The Commission has issued the enclosed Amendment No. 81 to Facility Operating License No. DPR-67 for the St. Lucie Plant, Unit No. 1. This amendment consists of changes to the Technical Specifications in response to your application dated March 17, 1987.

ST. LUCIE PLANT UNIT NO. 1

Amendment No. 81
License No. DPR-67

ATTACHMENT TO LICENSE AMENDMENT NO. 81
TO FACILITY OPERATING LICENSE NO. DPR-67
DOCKET NO. 50-335

FIGURE 3.1-1b
MAXIMUM ALLOWABLE HEATUP AND COOLDOWN RATES, SINGLE
HPSI PUMP IN OPERATION

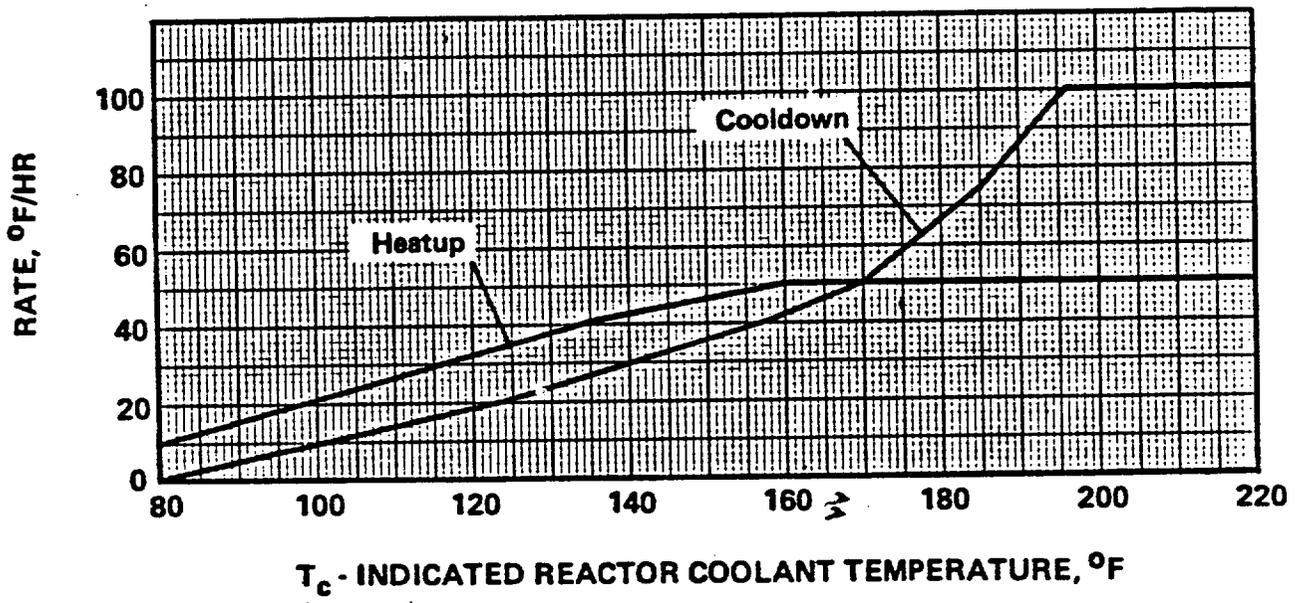
*The flow path from the RWT to the RCS via a single HPSI pump shall only be established if: (a) the RCS pressure boundary does not exist, or (b) no charging pumps are operable. In this case, all charging pumps shall be disabled, and heatup and cooldown rates shall be limited in accordance with Fig. 3.1-1b.

*The flow path from the RWT to the RCS via a single HPSI pump shall be established only if: (a) the RCS pressure boundary does not exist, or (b) no charging pumps are operable. In this case, all charging pumps shall be disabled and heatup and cooldown rates shall be limited in accordance with Fig. 3.1-1b.

*When the flow path from the RWT to the RCS via a single HPSI pump is established per 3.1.2.3, the heatup and cooldown rates shall be established in accordance with Fig. 3.1-1b.

FIGURE 3.4-2a
ST. LUCIE UNIT 1 P/T LIMITS, 10 EPFY
HEATUP AND CORE CRITICAL

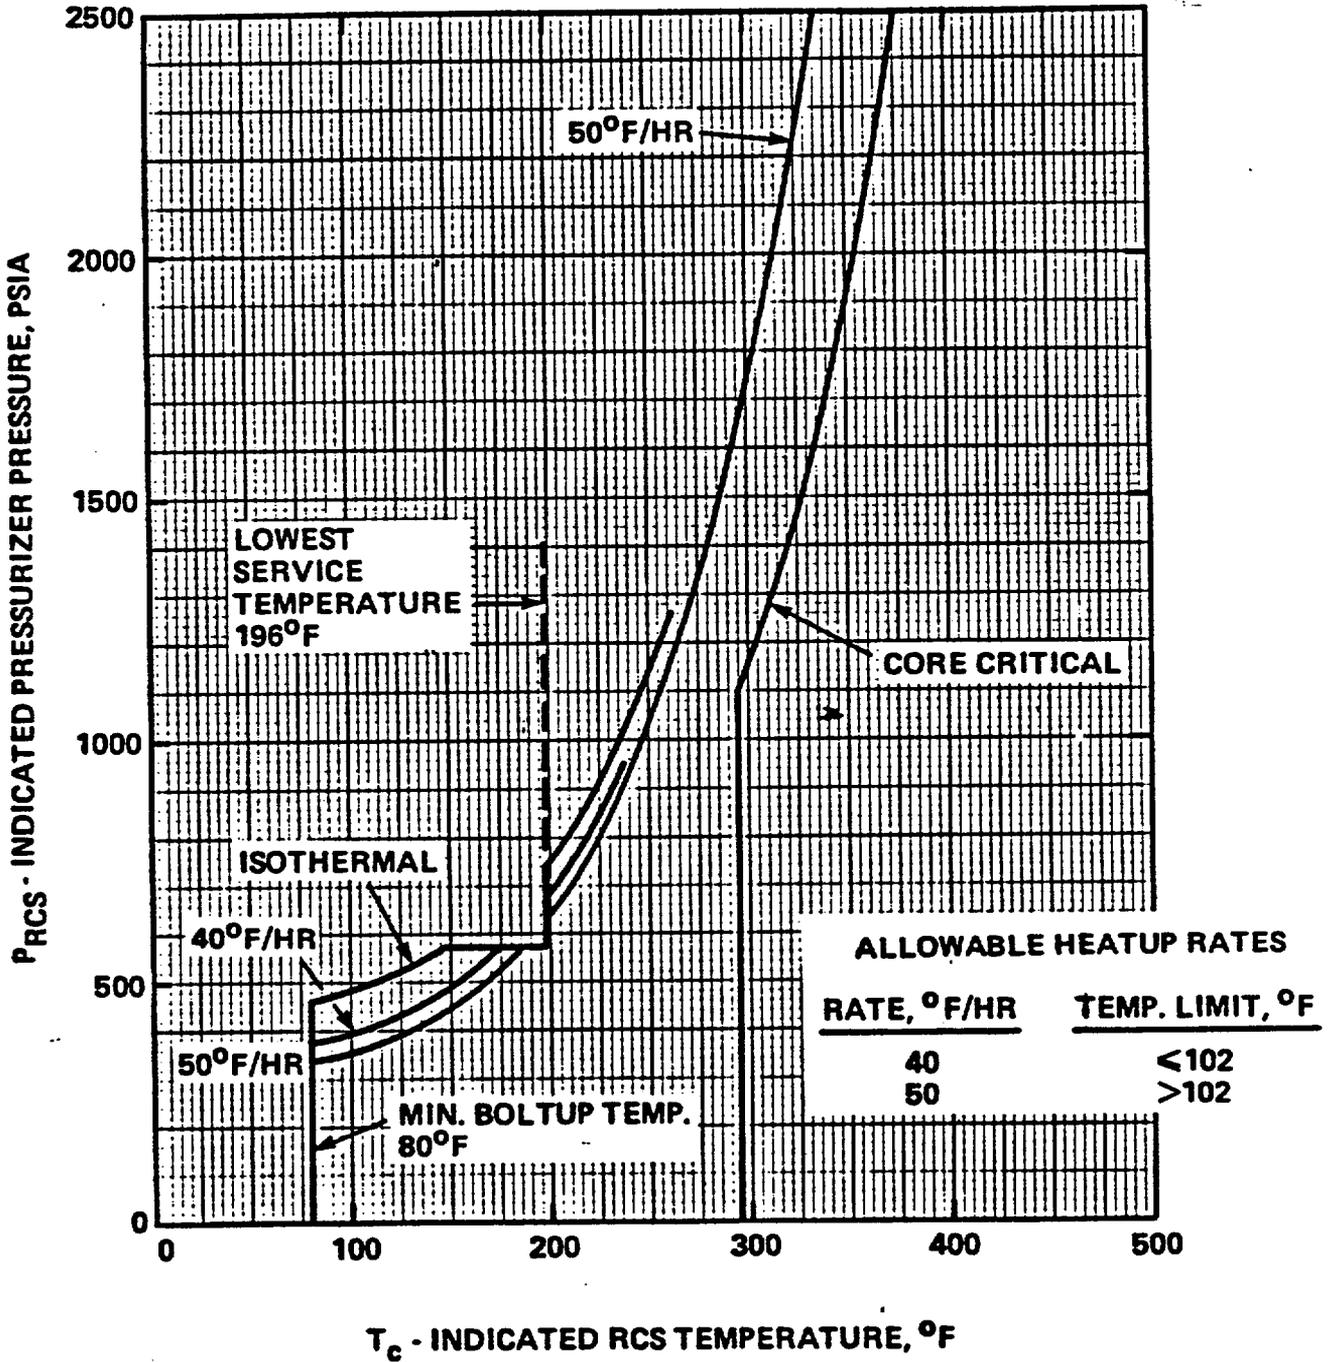
This amendment changes the Reactor Coolant System Pressure/Temperature (P/T) limit figures to be effective up to ten (10) effective full power years of operation. The amendment also changes the technical specifications dealing with overpressure protection systems because they are linked with the new P/T limit figures. The applicable bases sections are changed to reflect the above changes.

3.4.9.1 The Reactor Coolant System (except the pressurizer) temperature and pressure shall be limited in accordance with the limit lines shown on Figures 3.4-2a, 3.4-2b and 3.4-3 during heatup, cooldown, criticality, and inservice leak and hydrostatic testing.

The St. Lucie, Unit 1 design uses power operated relief valves (PORVs) for overpressure protection during low temperature operating conditions. Pressure/temperature (P/T) limits for plant cooldown and heatup are specified in Figures 3.4-2a, 3.4-2b and 3.4-2c of the Technical Specifications (TS). The licensee's analyses documented in Appendix 5B of FSAR include (1) a postulated inadvertent reactor coolant pump (RCP) start event, assuming a maximum secondary to primary temperature differential of 100°F, and (2) a postulated inadvertent safety injection actuation event, assuming two high pressure safety injection (HPSI) pumps and three charging pumps injecting water into the reactor coolant system (RCS) for temperatures above 195°F, one HPSI pump and three charging pumps injecting water into the RCS for temperatures below 195°F with one HPSI pump disabled and three charging pumps injecting water into the RCS for temperatures below 155°F with both HPSI pumps disabled. All the above analyses performed to support LTOP system assume only one PORV operating during the overpressure transients.

Based on the results of a pressure transient analysis for the above events and the P/T limits presented in the revised Figures 3.4-2a, 3.4-2b and 3.4-3, the licensee, in its letter dated March 17, 1987, proposed system modifications and administrative controls as follows:

The licensee's above listed proposed modifications have been reflected in its proposed TS changes given in the introduction section of this report. The staff has reviewed the results of the licensee's reanalysis of pressure transients and its proposed TS changes and concludes that the proposed changes are adequate to prevent violation of the Appendix G P/T limits during an operating period ending at 10 EFPY.

Based on the above evaluation, the staff concludes that the licensee's proposed changes to TS Sections 1.16, 4.1.2.1, 4.1.2.3, 3.4.1.4.1, 3.4.9.1, 4.4.9.1, 3.4.13, 4.4.13, 3.4.14, 4.4.14, 3.5.3, 3/4.1.2, 3/4.4.1, 3/4.4.9, 3/4.4.13, 3/4.5.2, and 3/4.5.3 with its proposed modifications as submitted in its letter dated March 17, 1987 are acceptable. The proposed LTOP system is designed in accordance with the requirements set forth in the Branch Technical Position RSB 5-2 and it is adequate to prevent violation of the Appendix G P/T limits during an operating period ending at 10 EFY. Implementation of the proposed LTOP system will not result in a reduction in the margin of safety presently afforded by TS. Therefore, the staff concludes that the licensee's proposed modifications of system design, administrative controls, and their associated TS changes are acceptable.

**FIGURE 3.4-3
ST. LUCIE UNIT 1, 10 EFPY
MAXIMUM ALLOWABLE COOLDOWN RATES**

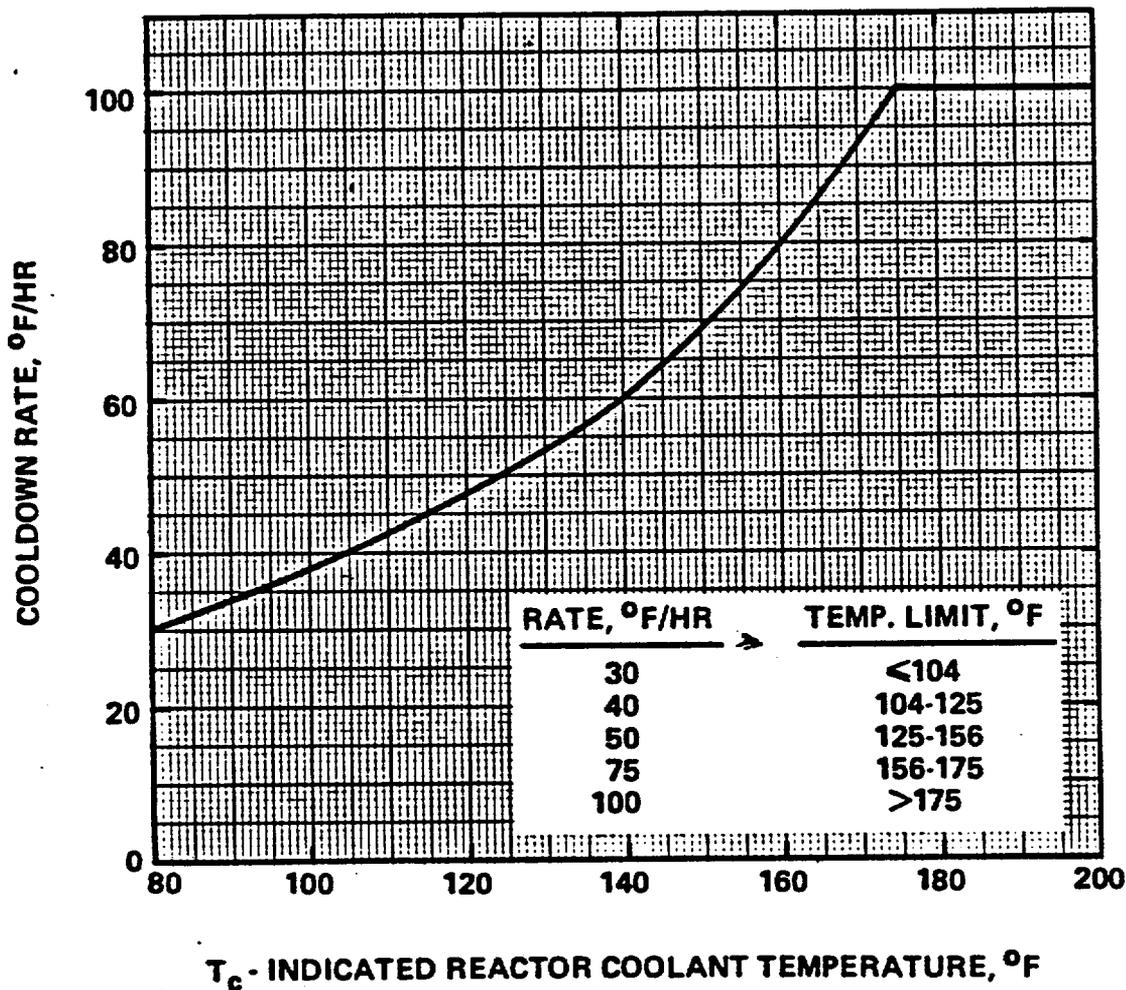
**NOTE: A MAXIMUM COOLDOWN RATE OF
100°F/HR IS ALLOWED AT ANY
TEMPERATURE ABOVE 175°F**
